Bauer Heights Plat 4 – Major Preliminary Plat

Preliminary Plat Approval of a Major Subdivision Plat

Bauer Heights Plat 4
Major Preliminary Plat

Sheet 1 of 4

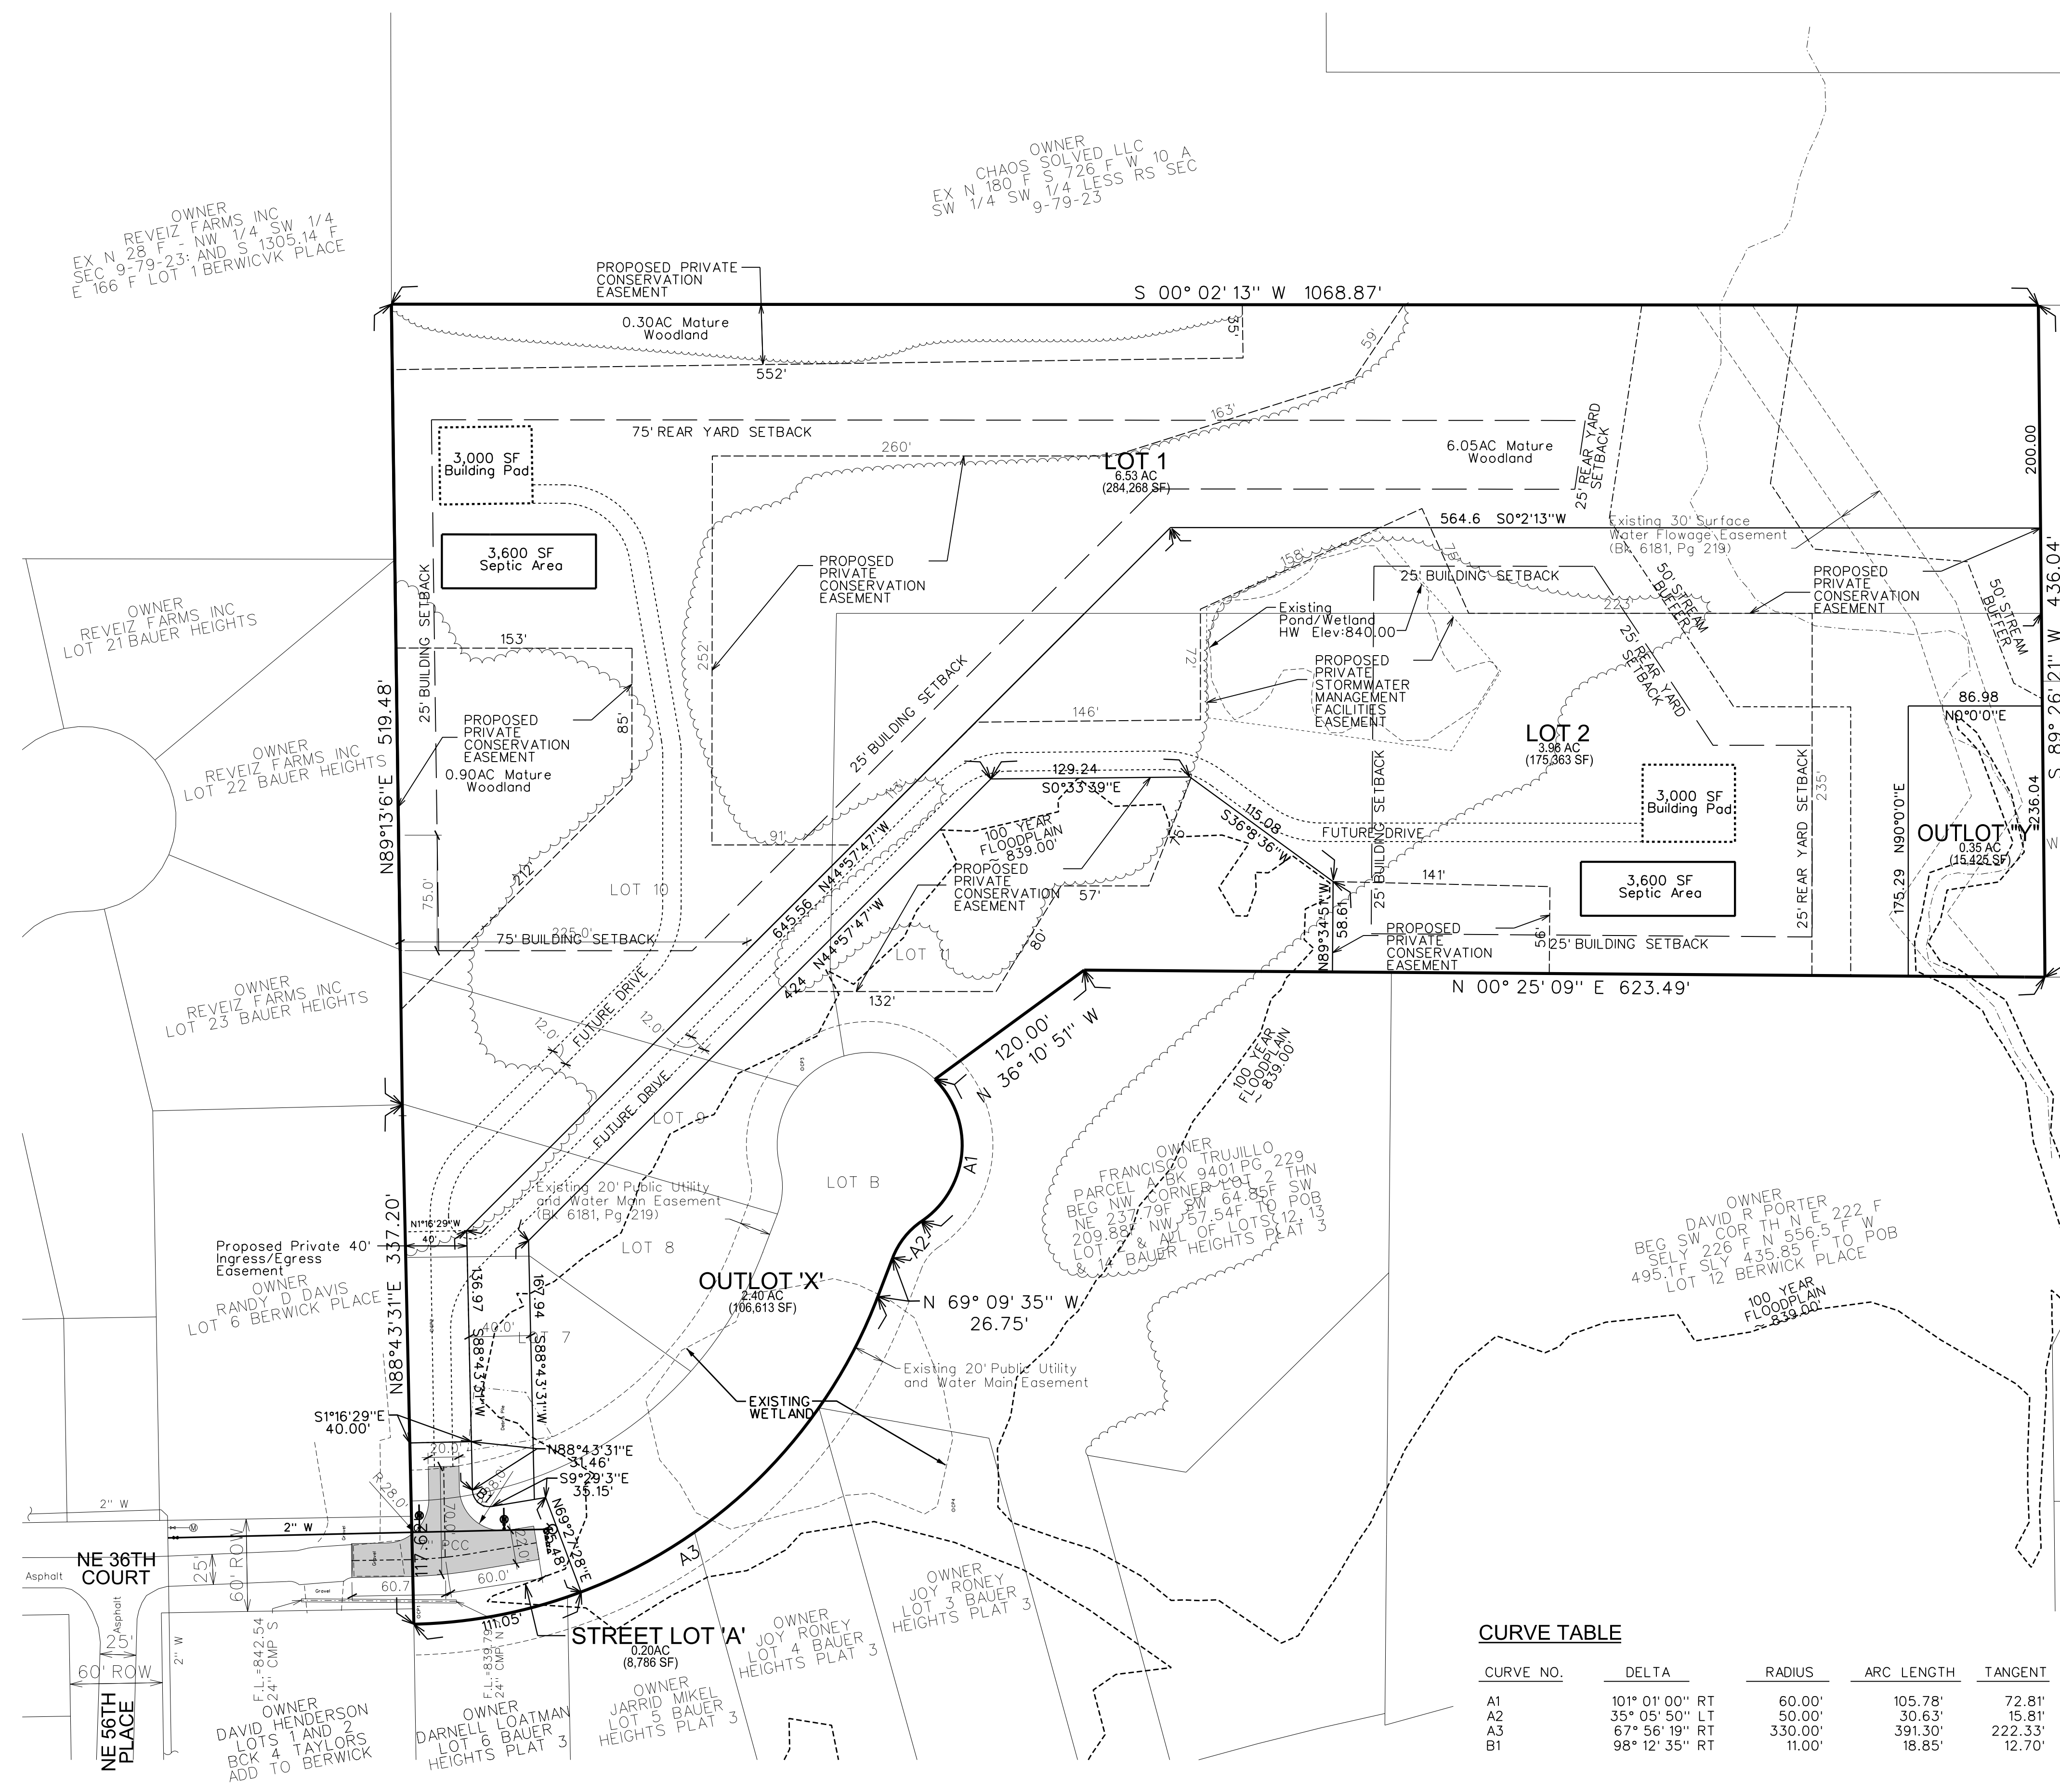
Flag lots shall not exceed three (3) acres in size in areas without public sanitary sewer (Lot 1 and Lot 2).

Flag lots shall have a maximum flagpole length of 400 feet (Lot 2).

Staff recommends approval of the Preliminary Plat of Bauer Heights Plat 4, as well as the requested waivers to the flag lot requirements. Staff is supportive of the flag lot waivers due to the site topography, floodplain and other natural resources on the property. The proposed lot configuration and requested waivers serve to protect these natural features while providing adequate buildable areas for each lot.
